UNITED STATES PATENT AND TRADEMARK OFFICE

APPLICATION NO.	FILING DATE	FIRST NAMED INVENTOR	ATTORNEY DOCKET NO.	CONFIRMATION NO.
10/803,779	03/18/2004	Hirofumi Harada	S004-5242	8062

Office Action Summary

DETAILED ACTION

FIG. 1

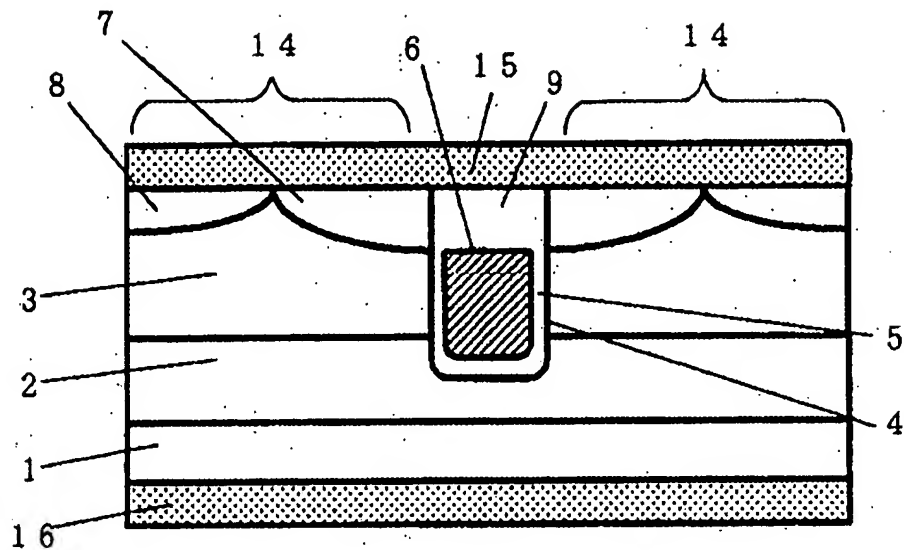
Regarding claim 9, APA (Fig. 1) further discloses a metallic drain electrode 16 connected to a second surface of the semiconductor substrate opposite to the first surface thereof.

FIG. 2 Prior Art

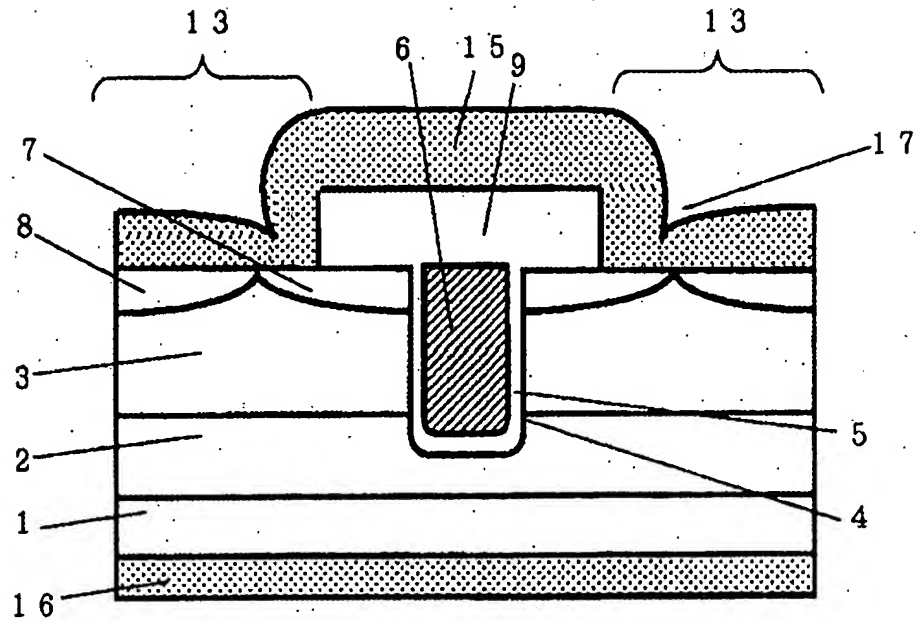
Regarding claims 1, 7 and 10, APA (Fig. 2) discloses a vertical MOS transistor comprising: a semiconductor substrate 1 of a first conductivity type (see Specification, page 1, lines 10-11); an epitaxial growth layer 2 of the first conductivity type which is formed on the semiconductor substrate 1 (see Specification, page 1, lines 8-11); a body region 3 of a second conductivity type which is formed on the epitaxial growth layer 2

(see Specification, page 1, lines 14-17); a heavily doped body contact region 8 of the second conductivity type which is formed on a part of a surface of the second conductivity type body region 3 (see Specification, page 1, lines 18-21); a heavily doped source region 7 of the first conductivity type (see Specification, page 1, lines 18-20), which is formed on a part of the surface of the second conductivity type body region that is covered with the heavily doped body contact region 8 (see Fig. 2 labeled by the examiner below); a silicon trench 4 piercing the second conductivity type body region 3 and the first conductivity type source region 7 to reach an inner part of the first conductivity type epitaxial growth layer 2 (Specification, page 2, lines 6-8); a gate insulating film 5 formed along walls and bottom of the silicon trench 4 (Specification, page 2, line 8); a heavily doped polycrystalline silicon gate 6 buried in the silicon trench 4 while surrounded by the gate insulating film 5 (Specification, page 2, lines 8-10); an intermediate insulating film 9 formed on the polycrystalline silicon gate 6 in the silicon trench 4 to reach a surface the semiconductor substrate 1; a metallic source electrode 16 being in contact with the intermediate insulating film 9, the heavily doped source region 7, and the heavily doped body contact region 8; and a metallic drain electrode 16 connected to a rear surface of the semiconductor substrate 1 (see Fig. 2 labeled by the examiner below).

APA does not disclose a heavily doped polycrystalline silicon gate 6 buried in the silicon trench 4 to a level of the first conductivity type source region 7, and an insulator disposed on the sidewalls of the trench and above the gate.
